Statement of Basis

**Permit to Construct No. P-2012.0043
Project ID 61312**

**McCain Foods
Burley, Idaho**

SUBJECT: Modeling Review for McCain Foods, Burley, Facility ID 031-00014
Reconfigure Prime 2 (B2) Process Line (replace B2 dryer and fryer), Remove Parfry fryer, Replace the 4 existing B2 Dryer Stacks with 3 new 120-ft tall stacks, and Increase the B2 Fryer Stack Height to 120 ft AGL

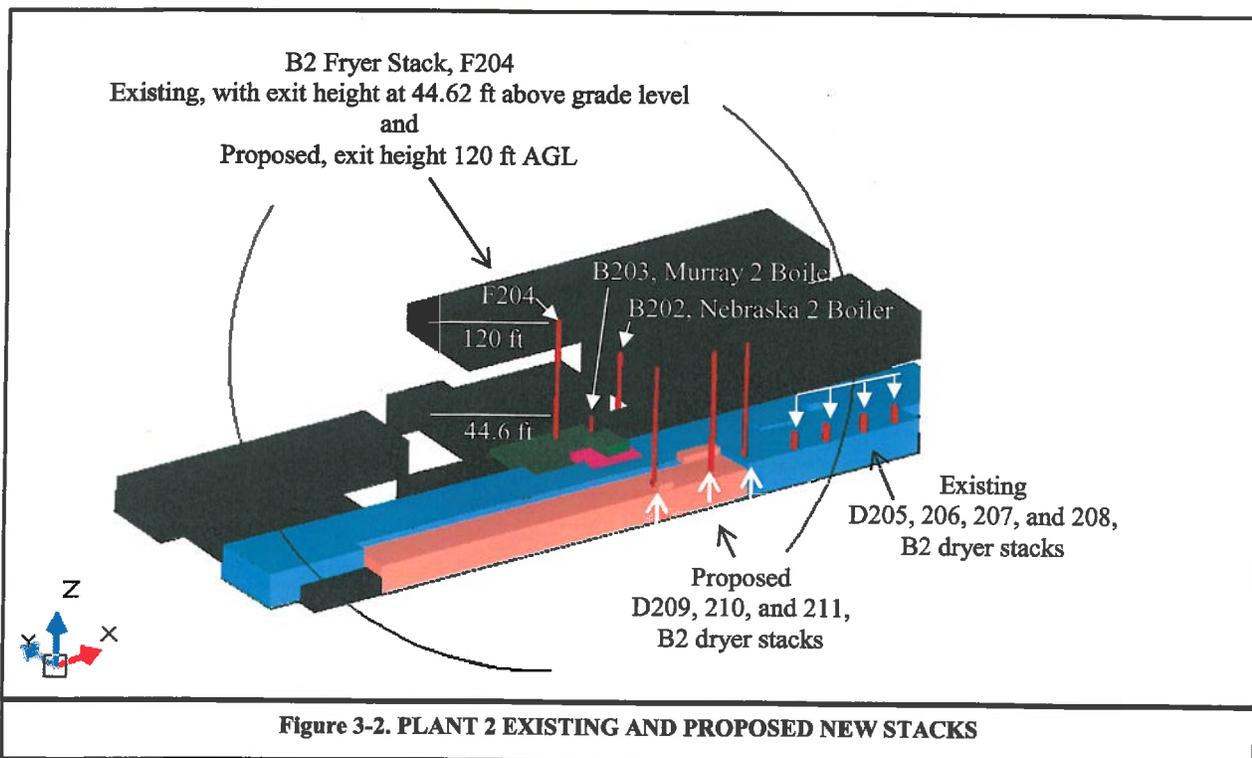
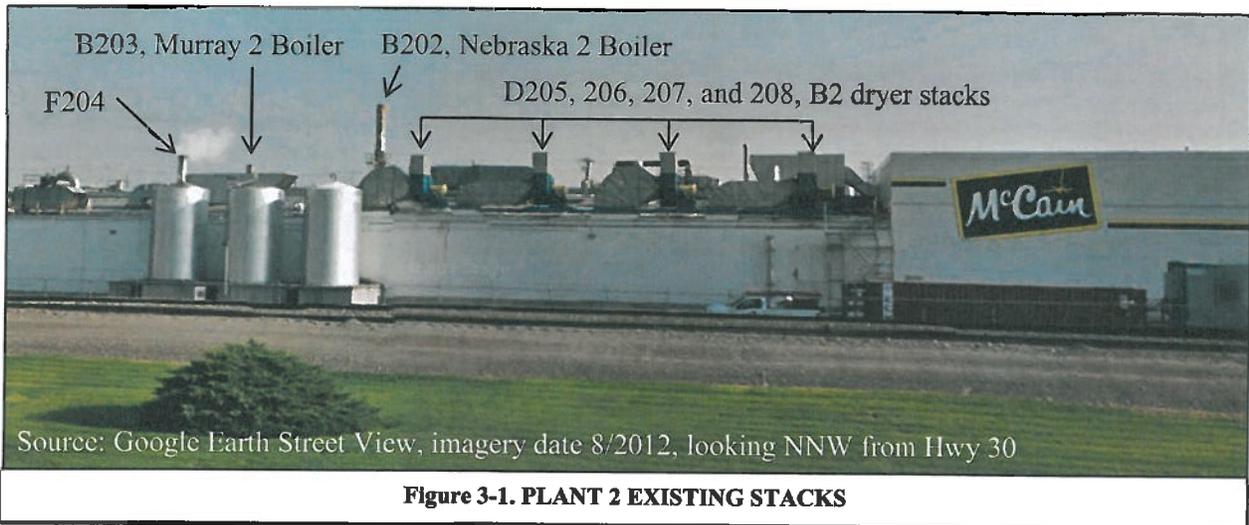
The existing Plant 2 stacks are shown in Figure 3-1, and the existing and new stacks are shown in Figure 3-2. McCain has asserted that the exit temperature and exhaust velocities from the three new B2 dryer stacks will be comparable to the exhaust temperature and velocity from the four existing B2 dryer stacks. Similarly, McCain has asserted that the exhaust temperature and velocity from the proposed 120-ft tall stack for the B2 fryer will be comparable to the exhaust temperature and velocity from the existing 44.6-ft stack.
